Title - Sujet Federal Ops. Building Demolition	
Solicitation No. - N° de l'invitation EZ899-172265/B	Amendment No. - N° modif. 003
Client Reference No. - N° de référence du client	Date 2017-04-13
GETS Reference No. - N° de référence de SEAG PW-\$PWY-033-8029	
File No. - N° de dossier PWY-6-39278 (033)	CCC No./N° CCC - FMS No./N° VME
Solicitation Closes - L'invitation prend fin at - à 02:00 PM on - le 2017-04-21	Time Zone Fuseau horaire Pacific Daylight Saving Time PDT
F.O.B. - F.A.B. Plant-Usine: <input type="checkbox"/> Destination: <input checked="" type="checkbox"/> Other-Autre: <input type="checkbox"/>	
Address Enquiries to: - Adresser toutes questions à: Lam, Tian PWY	Buyer Id - Id de l'acheteur pwy033
Telephone No. - N° de téléphone (604) 775-9382 ()	FAX No. - N° de FAX () -
Destination - of Goods, Services, and Construction: Destination - des biens, services et construction: CBSA - Federal Operations Building - Surrey, BC

ADDENDUM #1

SURREY FEDERAL OPERATIONS BUILDING
DEMOLITION RE-TENDER
SURREY, B.C.
Project No: R.078656.001

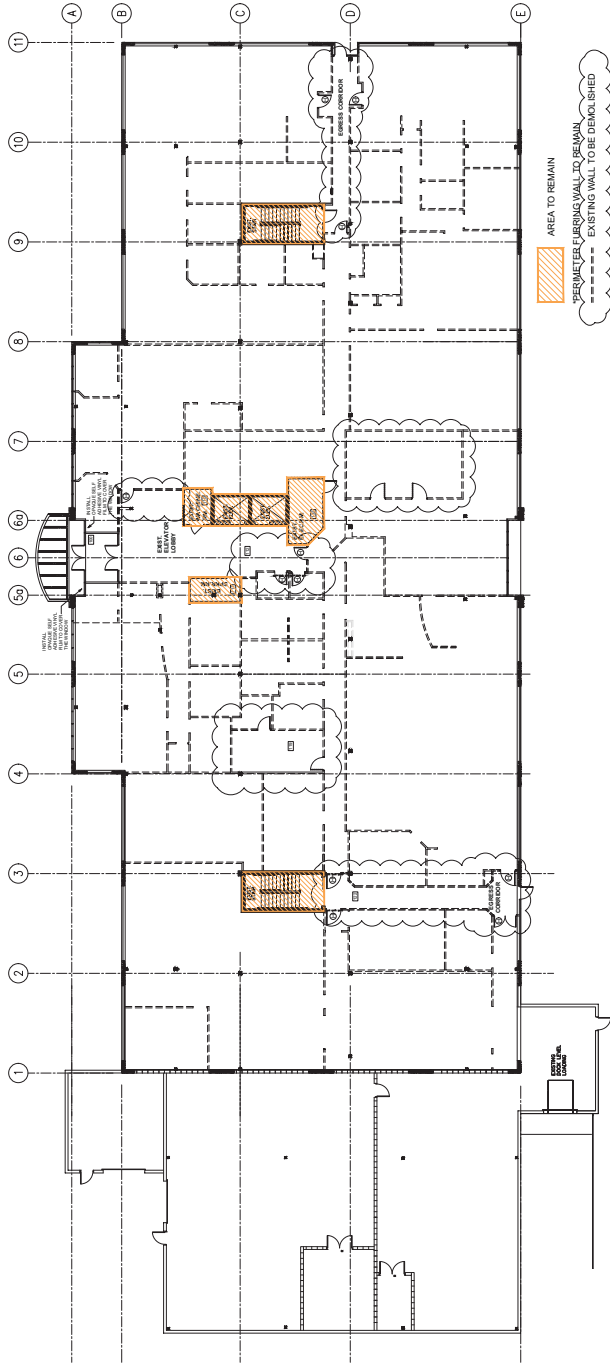
3.5.Q. Regarding the Liebert condensing units on the roof, could you please confirm if those are to remain or do we need to remove them? The plans show small boxes representing CU-1,2, and 3 on the roof, which I assume to be the Liebert units, however it is not identified whether they are to be removed or not. There is a note that says to demolish all split dx units, however I would assume that this only applies to the smaller split systems (with the wall mounted and/or ceiling hung ones) although it's possible that it could apply to the larger Lieberts as well. Could you please confirm?

A. The Liebert units on the roof to remain. The indoor units in the old Server Room to return to Owner for re-use, if desired.

1 MAIN FLOOR DEMOLITION PLAN
A004 1 : 150

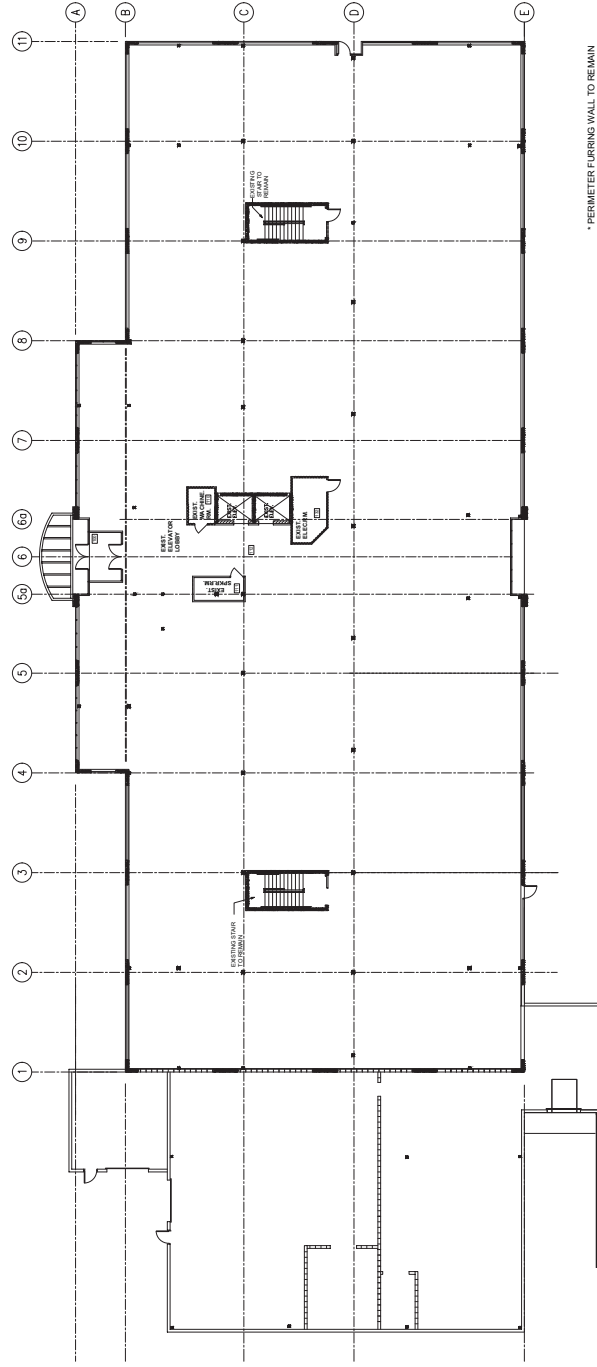
- A001 LOCATION PLAN, SITE PLAN & GENERAL NOTES
- A004 MAIN FLOOR DEMOLITION PLAN
- A005 MAIN FLOOR DEMOLITION CEILING PLAN
